Source: TSG_N WG "1"
Title: CRs to 3G Work Item "GPRS"
Agenda item: 6.13
Document for: APPROVAL

This document contains "11" CRs on **Work Item "GPRS"**, that have been agreed by **TSG_N WG "1"**, and are forwarded to **TSG_N Plenary meeting #8** for approval.

24.008 CR 209

Network behaviour, abnormal cases detach

Figure 1 If SGSN and MS uses local TLLI while P-TMSI is not validated

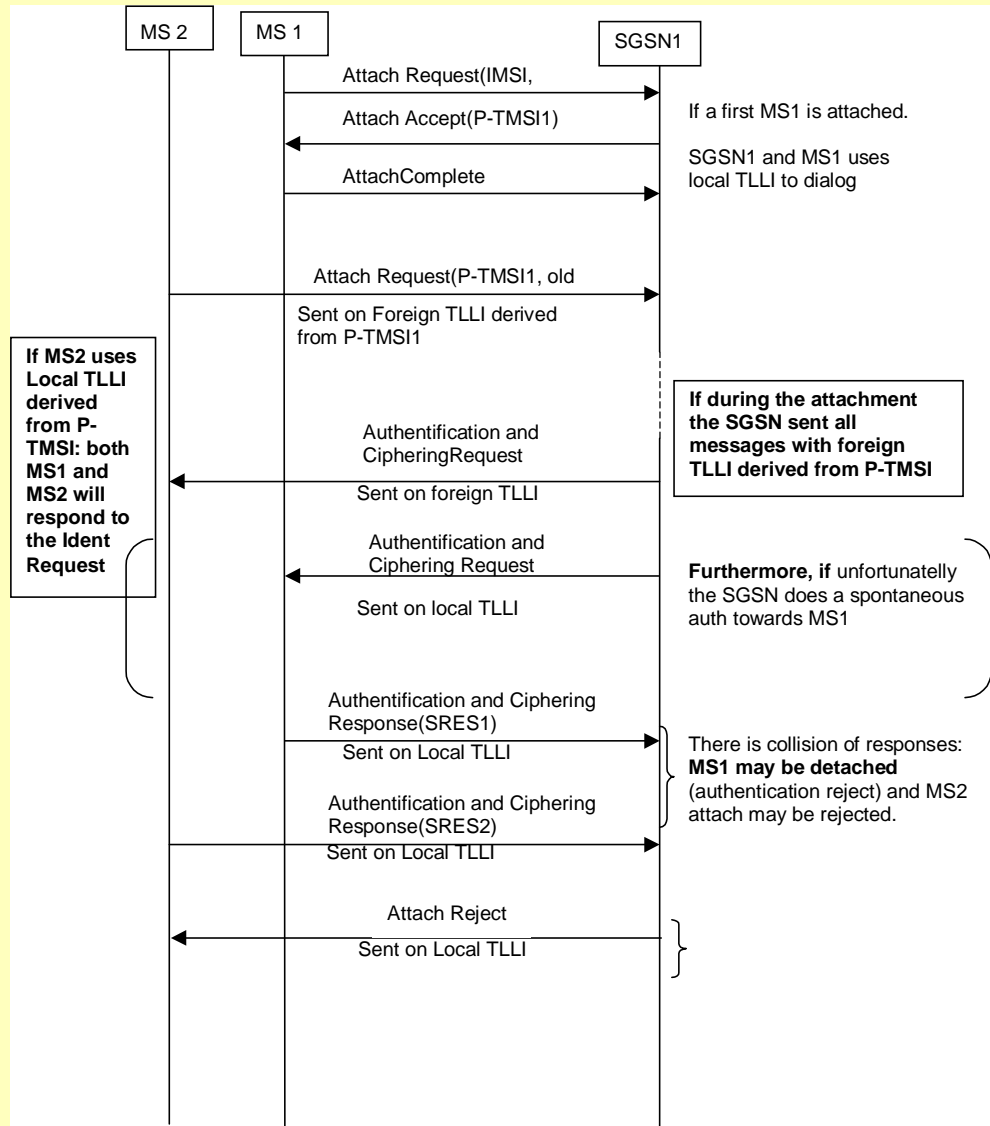
GSM 04.08, section 4.7.1.4 is inconsistent with this description because it only deals with the ATTACH REQUEST (respectively ROUTING AREA UPDATE REQUEST) message and do not refer to the Attach (respectively Routing Area Update) procedure as a whole. Therefore, some MS may send any other message during these procedures (as Authentication and Ciphering Response or Identity Response) with a local TLLI and may wait for messages on local TLLI, which may lead the procedure to fail and may cause some collision cases. To prevent this, this CR tries to clarify the TLLI handling described in GSM 04.08 during the Attach or during the Routing Area Update procedure when a foreign TLLI shall be used.

Following collision have been identified in case Foreign TLLI in not used for the procedures inside the Attach (or RAU) procedure:

- Consider an MS1 that is successfully attached to SGSN1, P-TMSI1 is allocated to that MS1.
- If an MS2 that, unfortunately, has a P-TMSI with same value as P-TMSI1 tries to attach to SGSN1:

Figure 1 If SGSN and MS uses local TLLI while P-TMSI is not validated

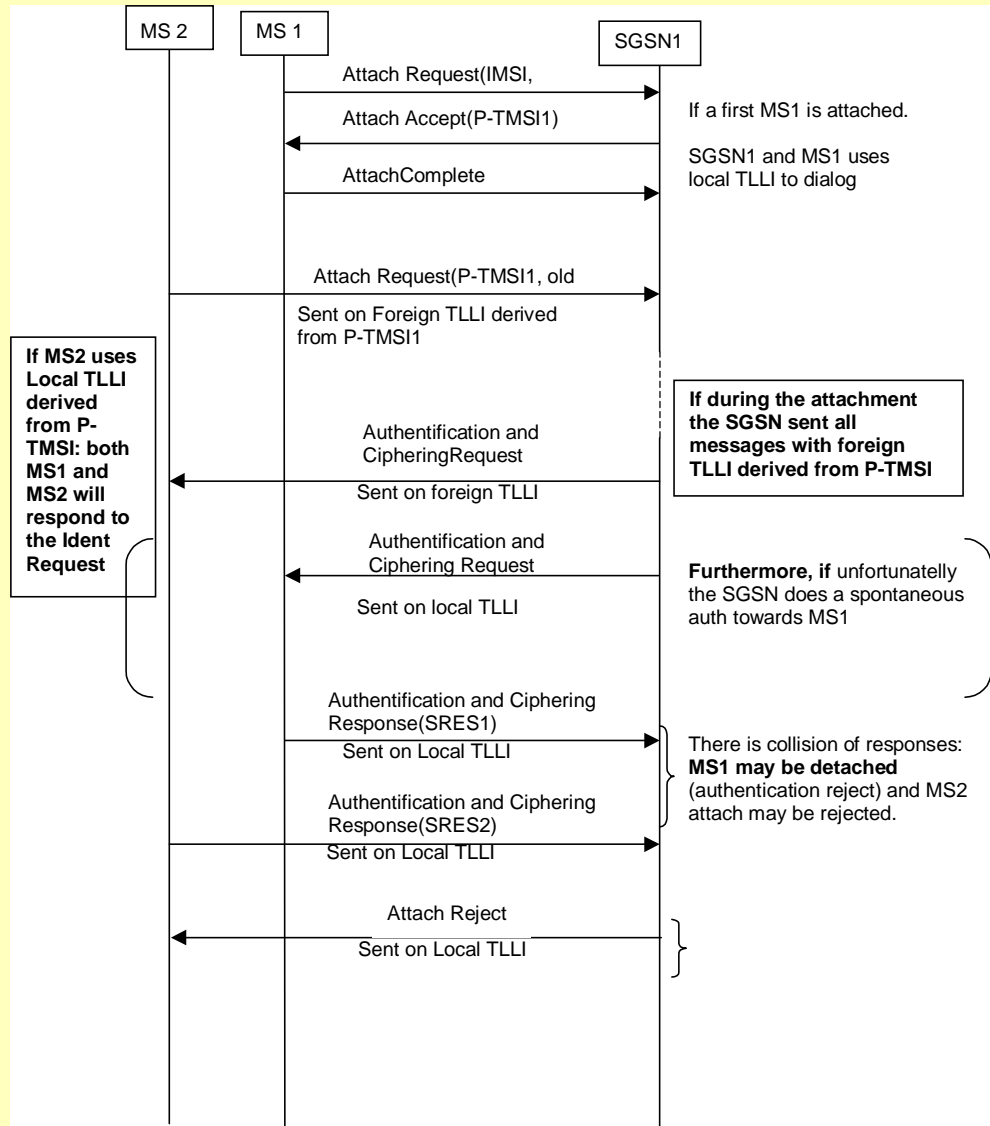
GSM 04.08, section 4.7.1.4 is inconsistent with this description because it only deals with the ATTACH REQUEST (respectively ROUTING AREA UPDATE REQUEST) message and do not refer to the Attach (respectively Routing Area Update) procedure as a whole. Therefore, some MS may send any other message during these procedures (as Authentication and Ciphering Response or Identity Response) with a local TLLI and may wait for messages on local TLLI, which may lead the procedure to fail and may cause some collision cases. To prevent this, this CR tries to clarify the TLLI handling described in GSM 04.08 during the Attach or during the Routing Area Update procedure when a foreign TLLI shall be used.

Following collision have been identified in case Foreign TLLI in not used for the procedures inside the Attach (or RAU) procedure:

- Consider an MS1 that is successfully attached to SGSN1, P-TMSI1 is allocated to that MS1.
- If an MS2 that, unfortunately, has a P-TMSI with same value as P-TMSI1 tries to attach to SGSN1:

Figure 1 If SGSN and MS uses local TLLI while P-TMSI is not validated

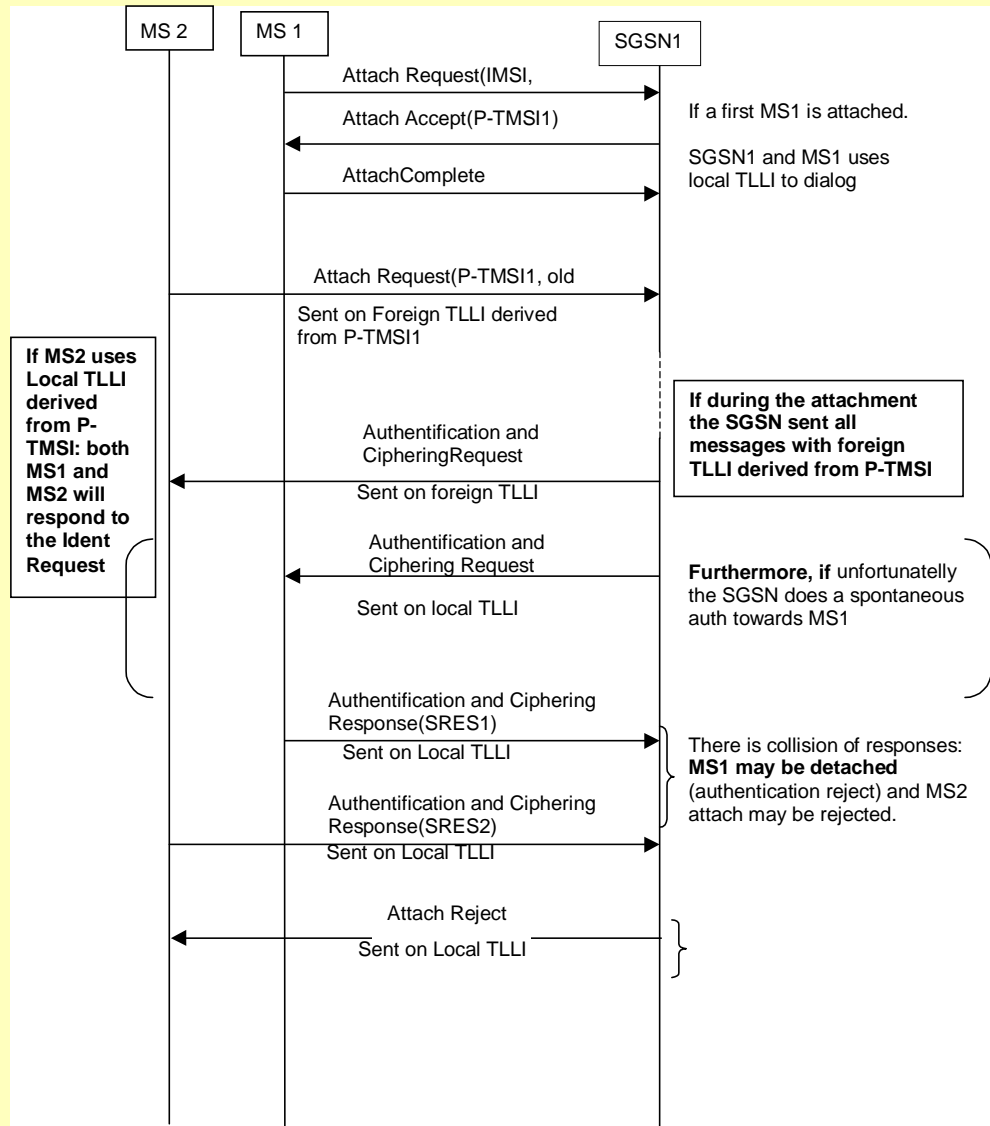
GSM 04.08, section 4.7.1.4 is inconsistent with this description because it only deals with the ATTACH REQUEST (respectively ROUTING AREA UPDATE REQUEST) message and do not refer to the Attach (respectively Routing Area Update) procedure as a whole. Therefore, some MS may send any other message during these procedures (as Authentication and Ciphering Response or Identity Response) with a local TLLI and may wait for messages on local TLLI, which may lead the procedure to fail and may cause some collision cases. To prevent this, this CR tries to clarify the TLLI handling described in GSM 04.08 during the Attach or during the Routing Area Update procedure when a foreign TLLI shall be used.

Following collision have been identified in case Foreign TLLI in not used for the procedures inside the Attach (or RAU) procedure:

- Consider an MS1 that is successfully attached to SGSN1, P-TMSI1 is allocated to that MS1.
- If an MS2 that, unfortunately, has a P-TMSI with same value as P-TMSI1 tries to attach to SGSN1:

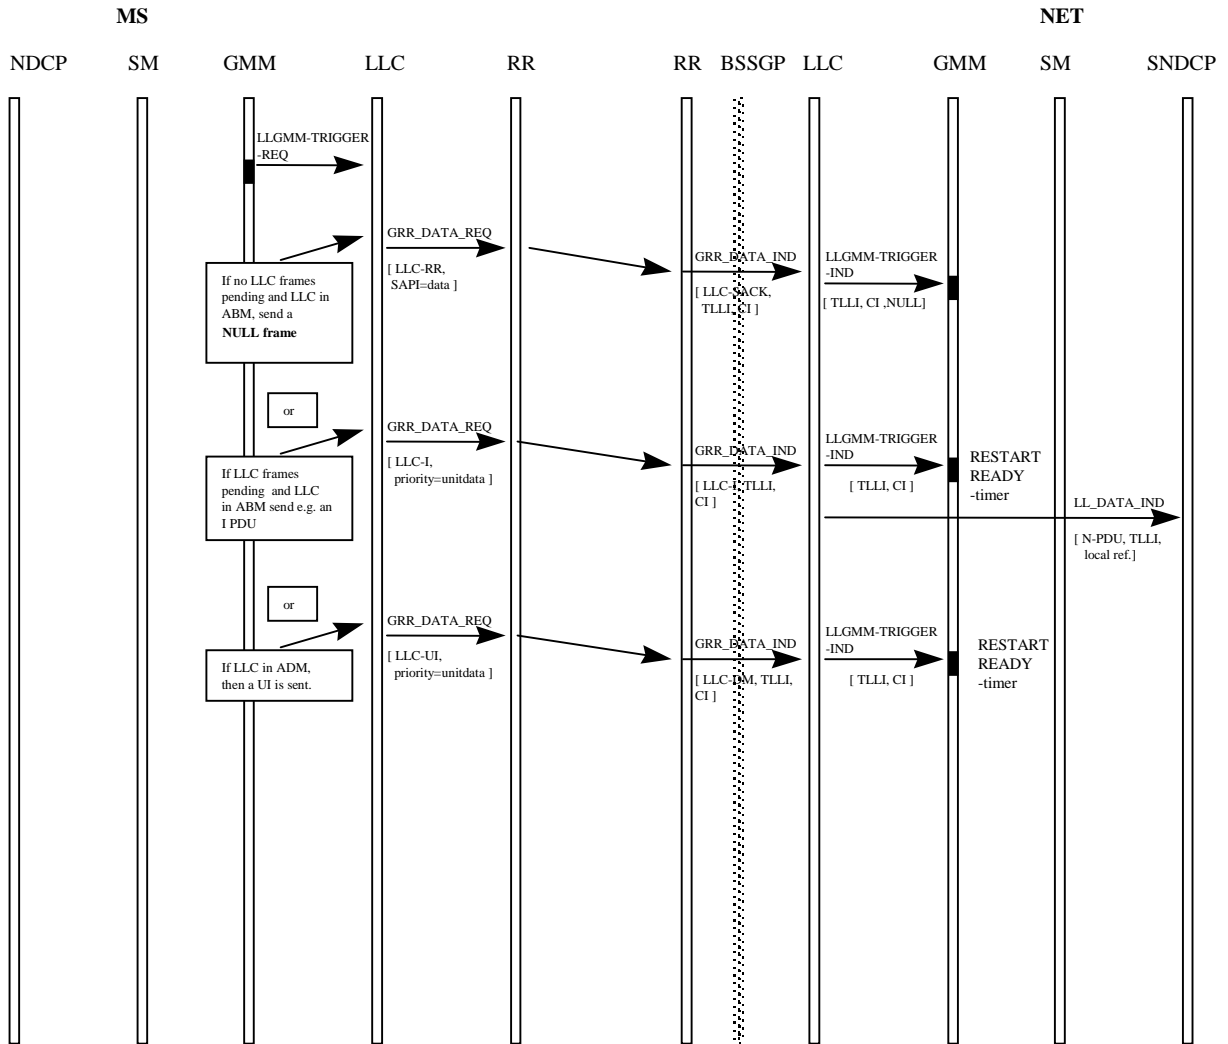
A new, optional information element (optional on syntax level but on semantic level mandatory for R99) is introduced into the ATTACH ACCEPT and ROUTING AREA UPDATE ACCEPT message to indicate the ability of the network to support the Cell Notification.

If both the MS and SGSN support the Cell Notification, and the ATTACH ACCEPT message or ROUTING AREA UPDATE ACCEPT message contains a new value of the READY timer, the MS shall send any LLC frame except the LLC NULL frame in order to start the READY timer (LLC NULL frame can not be sent because it does not trigger the start of the READY timer).
